MIDWAY MFG. CO.

TABLE OF CONTENTS

S E R V I C E B U L L E T I N

FIG. #1

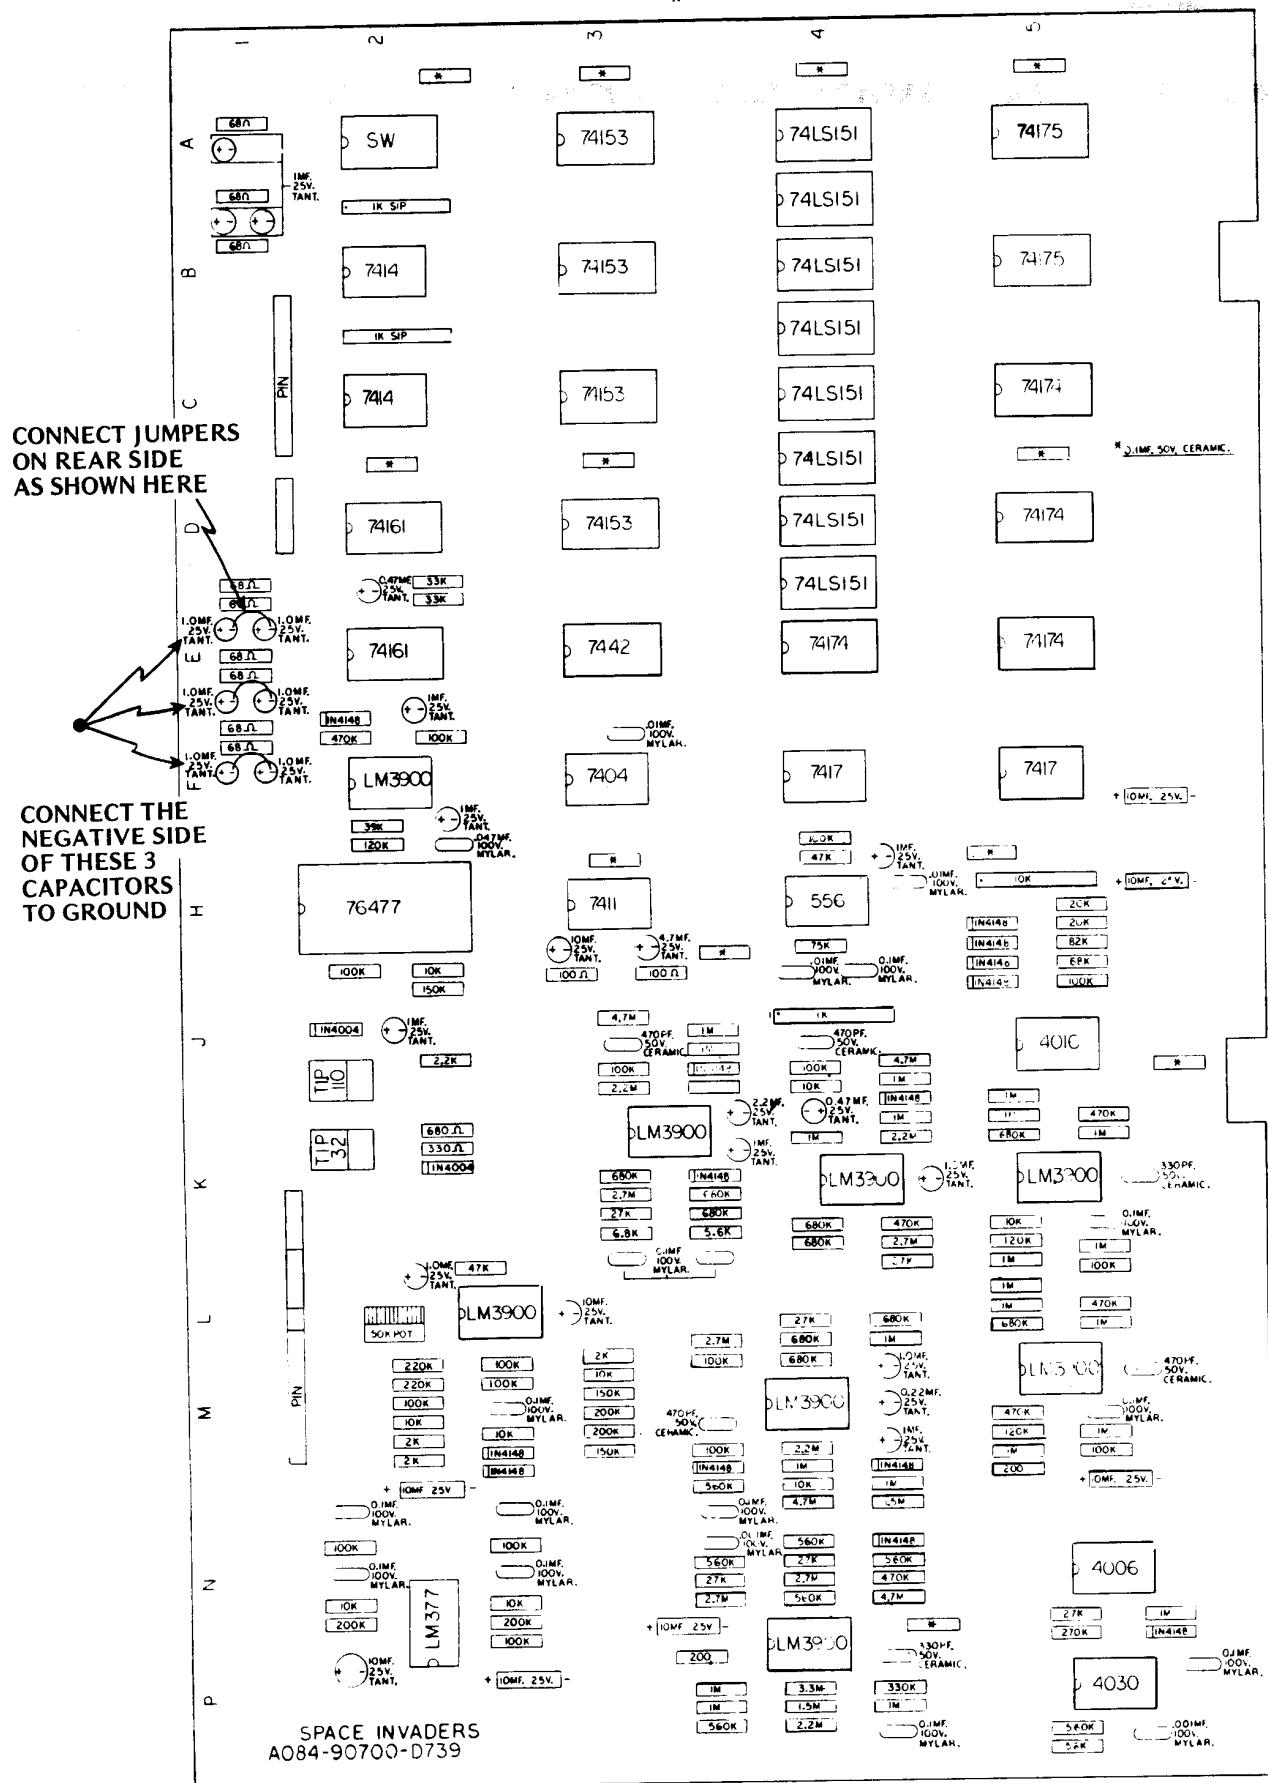
1. All A084-90700-739-D game boards have three capacitors which are not grounded (RRC Network).
2. Refer to Figure #1 for the location of 1.0MF-25V capacitors.
3. On rear side of game logic board, solder jumper wires from negative side of capacitor to ground (See Figure #1).
4. Check coin and control circuits electrically.

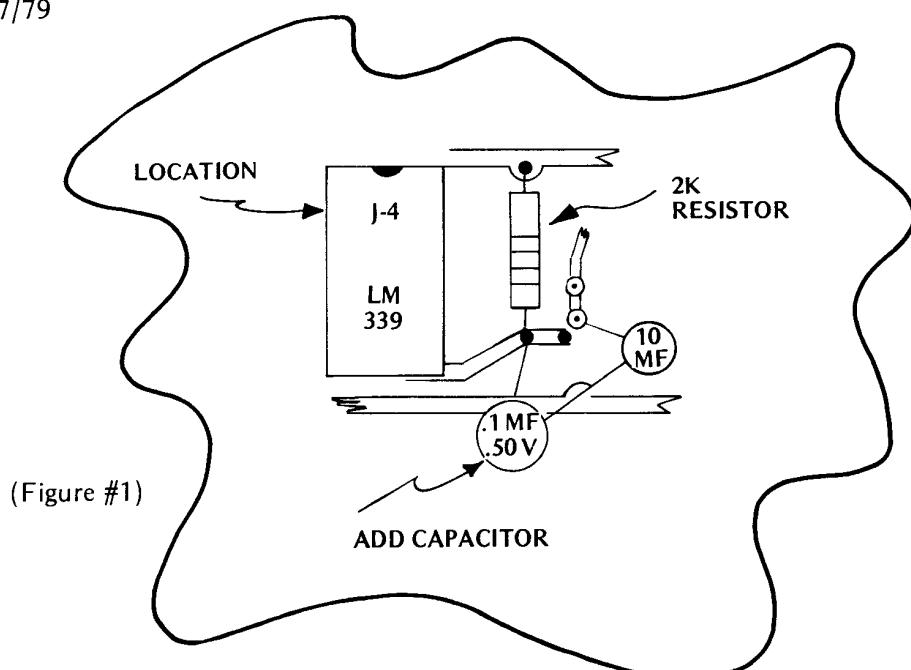
CONDITION: Premature Game Over (games serial #101 to 300)

1. Solder 0.1 MFD disc capacitor to the mother board PC A082-90400-B000, location J-4. (See Figure #1)
2. Check out game electrically.

"18 WHEELER" PROJECTOR FAN REWORK

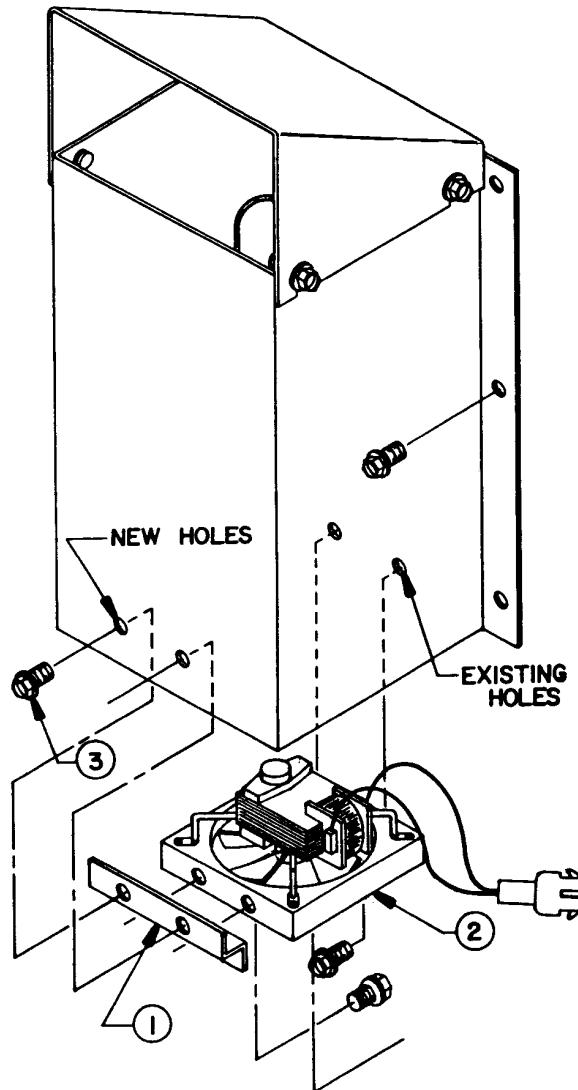
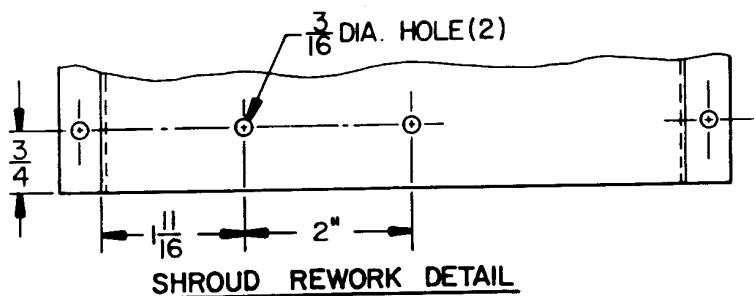
1. Remove 6 screws holding projector light shroud to pan and hub assembly.
2. Remove old fan and platform.
3. Assemble bracket (Item 1) to new exhaust fan (Item 2) as shown using self threading screws (Item 3).
4. This assembly gets fastened using the game holes and screws as the old fan platform.
5. Drill 2, 3/16 dia. holes in bottom of shroud as per dimensions on shroud rework detail.
6. Replace projector light shroud by first assembling 2 self threading screws through fan shroud to the fan mounting bracket (Item 1) and then the 6 remaining screws through the shroud to the pan and hub assembly.

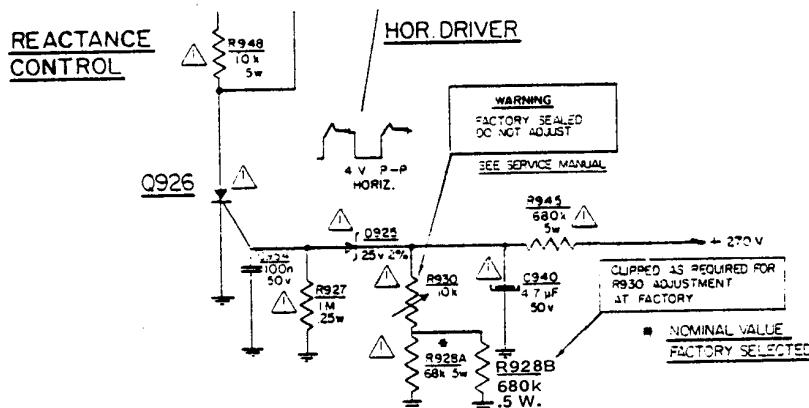
SYMPTOM: TV loses anode voltage, 30,000 VDC approximately, after 5 or 6 seconds.

CAUSE: On the Electrohome color monitor, the high voltage is protected by an overvoltage protection circuit. This circuit is probably too sensitive, or the 125 volt DC power supply is faulty.

SOLUTION: First determine if 125 volts DC is available on the power supply PCB. C940 could make it more sensitive if it has excessive leakage. Check R928B 680k .5 watt. If it's missing or clipped out, replace it. If R928B 680k is being used, change this resistor to one with a value of 510k .5 watt. If it is still too sensitive, change resistor to 470k .5 watt.

FIG. #1

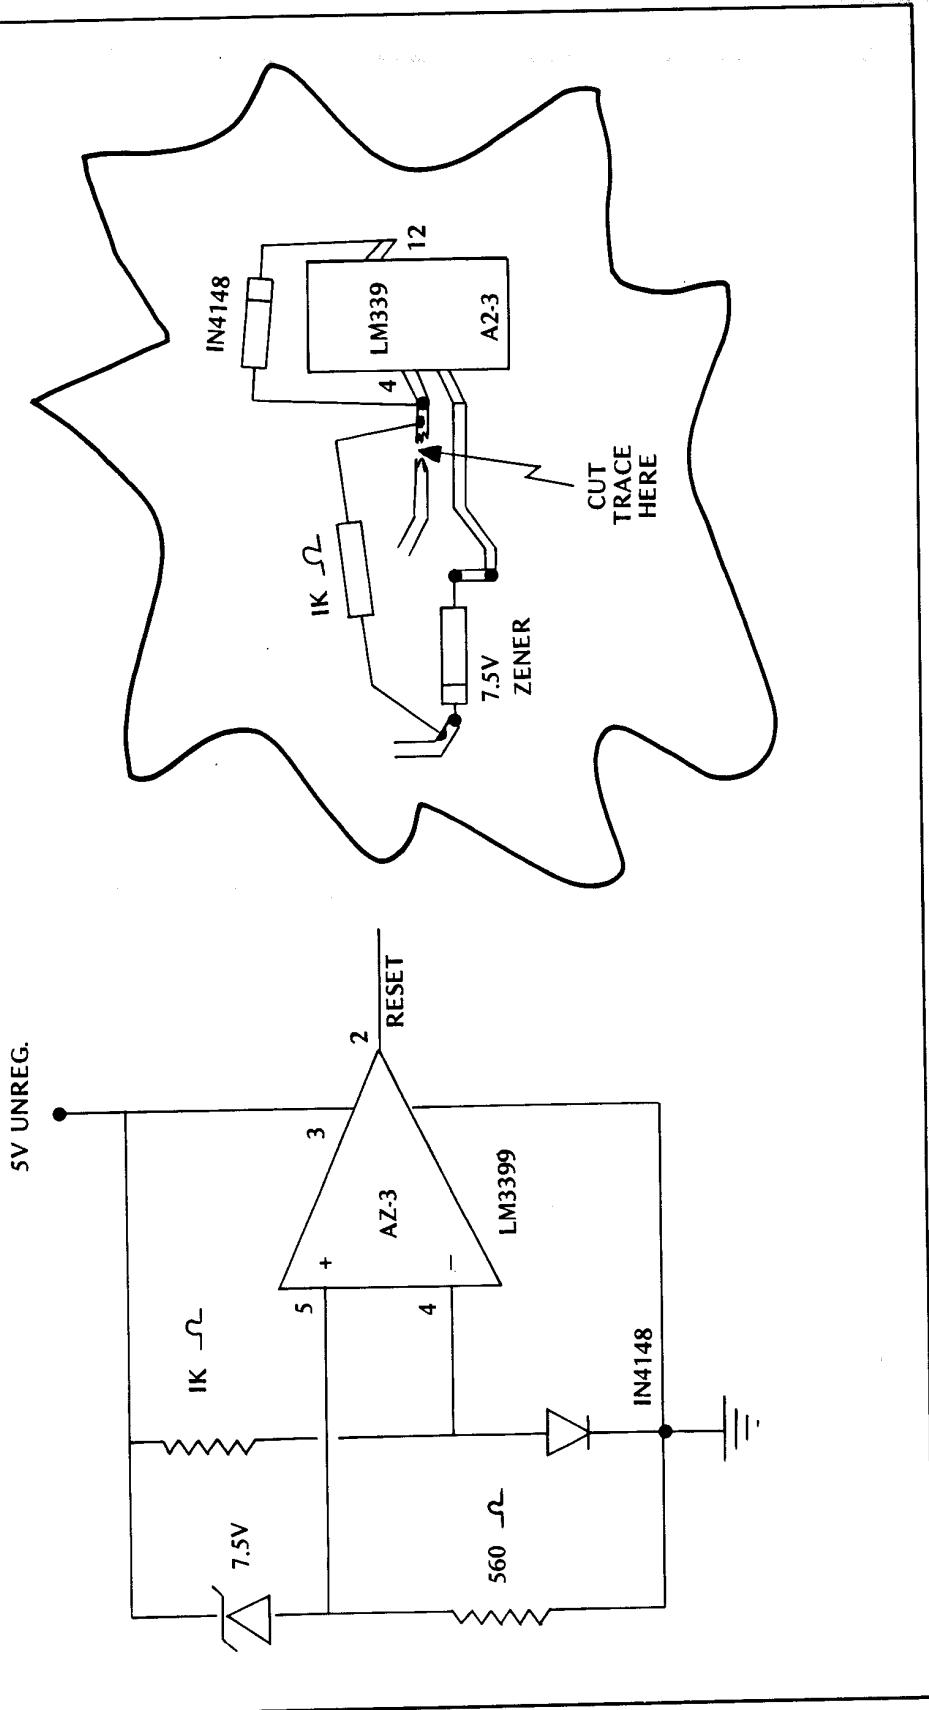
1. Replace the 2.7 volt zener in power reset circuit with a 7.5 volt zener.
2. Cut trace at pin 4 LM339 location A2-3. (See Fig. 1)
3. Solder a 1K resistor from pin 4 LM339 to the cathode of the 7.5 volt zener. (See Fig. 1)
4. Solder a IN4148 diode from pin 4 LM339 to ground (pin 12 LM339).
5. Check game out electrically.

FIGURE #2

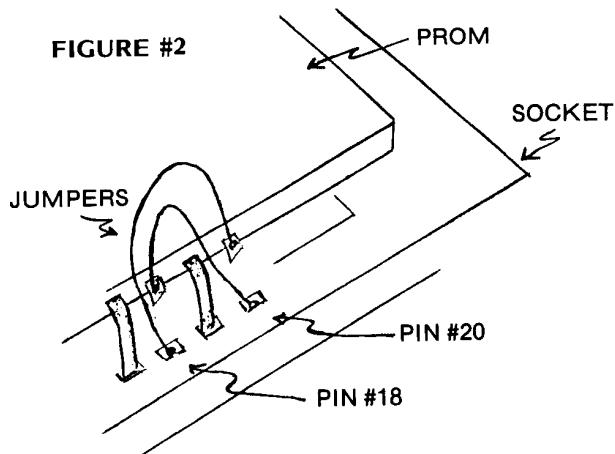
1. Refer to figure #1 for proper strapping of jumpers and capacitor removing or relocating.
2. Cut pins #18 and #20 of each prom and jumper as shown in figure #2.
3. Check electrically.

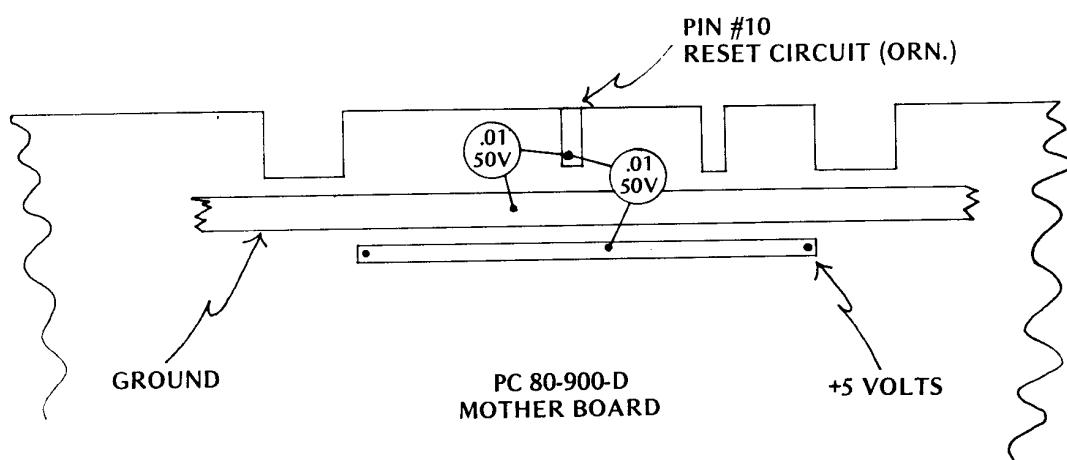
CONDITION: Random errors appearing on TV screen.

MODIFICATION: Add two .01 MFD capacitors to the mother board, PC 80-900; reset circuit (CPU) as shown below.
